Los Angeles Regional Water Quality Control Board

SUBJECT: REVIEW OF OFF-SITE ASSESSMENT WORK PLAN, PURSUANT TO CALIFORNIA WATER CODE SECTION 13304 CLEANUP AND

SITE: SKYPARK COMMERCIAL PROPERTIES (ASSESSOR PARCEL NO.

7377-006-906), 24701 - 24777 CRENSHAW BOULEVARD AND 2530, 2540, AND 2600 SKYPARK DRIVE, TORRANCE, CALIFORNIA (SCP

- 1. Figure 11 Proposed Sampling Locations
- 2. Table 1A COPC Concentrations in Soil
- 3. Figure 49 Lowe's Property Boring Locations (2004-2006 & 2020)

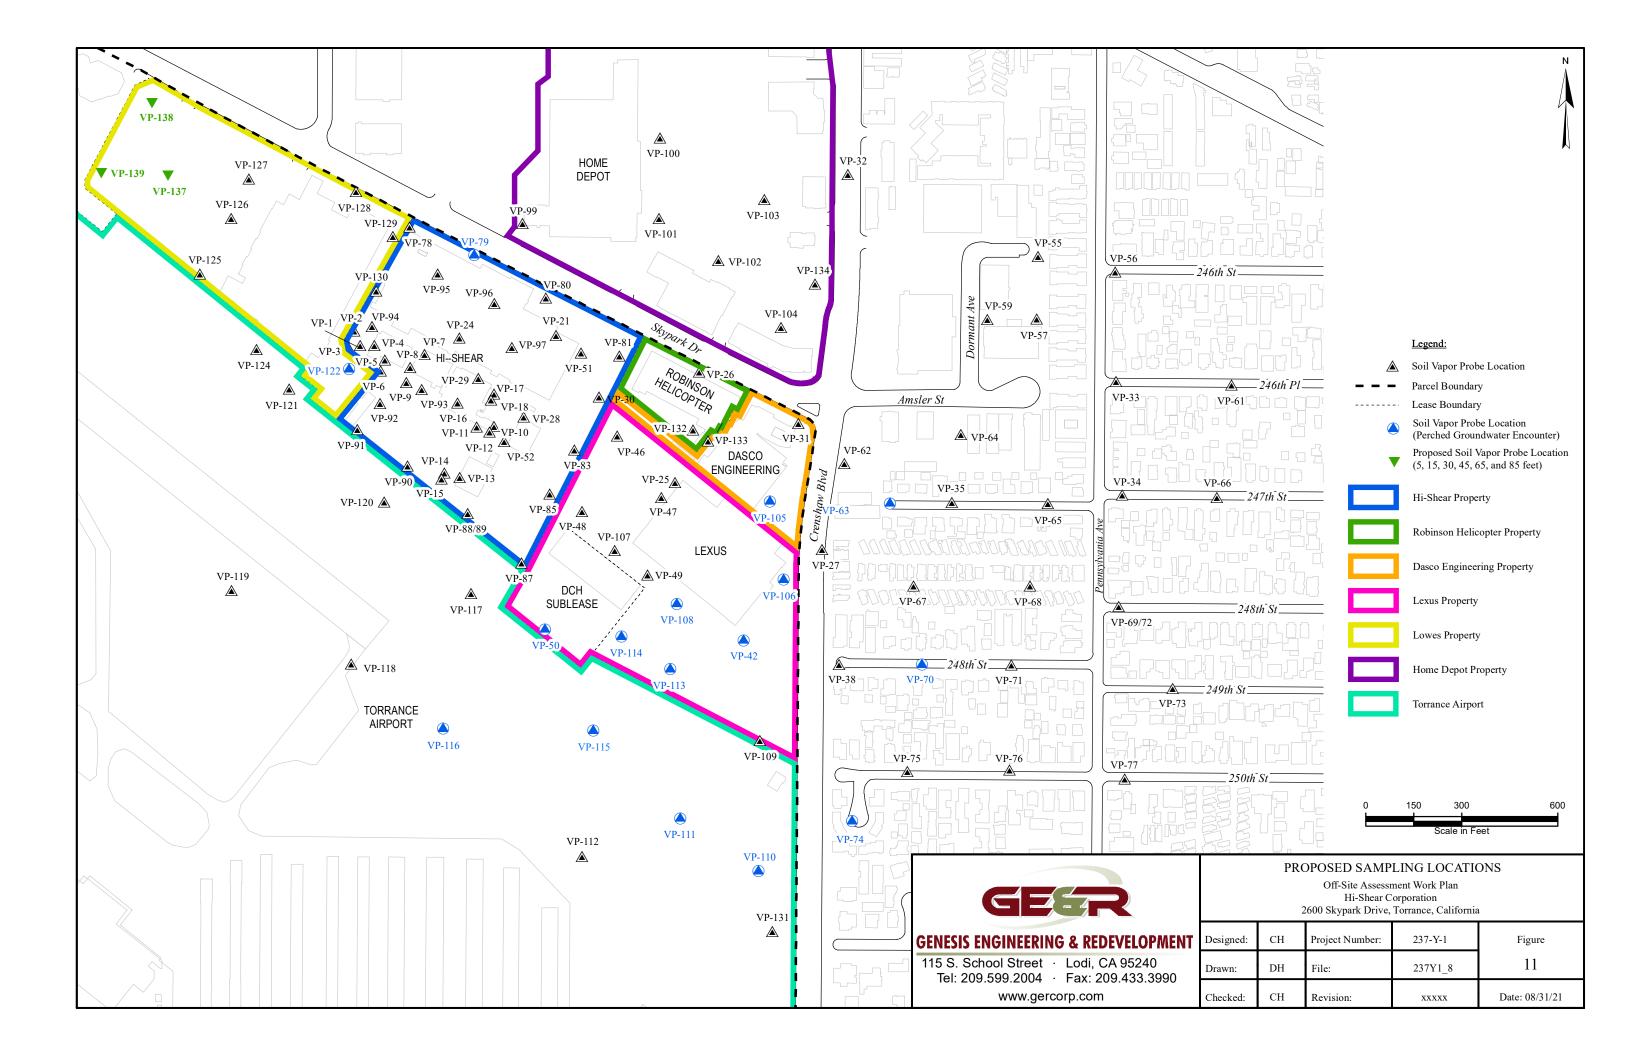
- Install nested soil vapor probes at three locations (VP-137 through VP-139) on the Lowe's Property, as shown in the attached Figure 11 – Proposed Sampling Locations
 - a. Soil vapor probes will be installed at 5, 15, 30, 45, 65, and 85 feet below ground surface (ft-bgs)
- 2. Sample the newly installed and existing soil vapor probes on the Lowe's Property, as shown in the table below, and analyze for VOCs using a mobile laboratory.

- 1. The offsite assessment shall not be limited to soil vapor as there may still be potential source(s) of VOC contamination on the Lowe's Property.
- 2. The lateral and vertical extent of VOC impacts south-southwest of the Lowe's Property (i.e., beyond soil vapor probe locations VP-121, VP-124, VP-125 [onto Torrance Airport]) and north-northwest of the 2600 Skypark Drive property (Hi-Shear Property) (i.e., beyond soil vapor probe locations VP-78, VP-127, VP-128, and VP-129 [across Skypark Drive]) has not been delineated and assessed. The concentrations of VOCs in soil vapor at these soil vapor probe locations are elevated and greater than applicable regulatory screening levels. Additional soil vapor probes should be proposed south-southwest of the Lowe's Property and north-northwest of the Hi-Shear Property to delineate the soil vapor plume.

- 6. Submit a revised Work Plan addressing the Los Angeles Water Board Comments No. 1 to 5 by **August 5, 2022**.
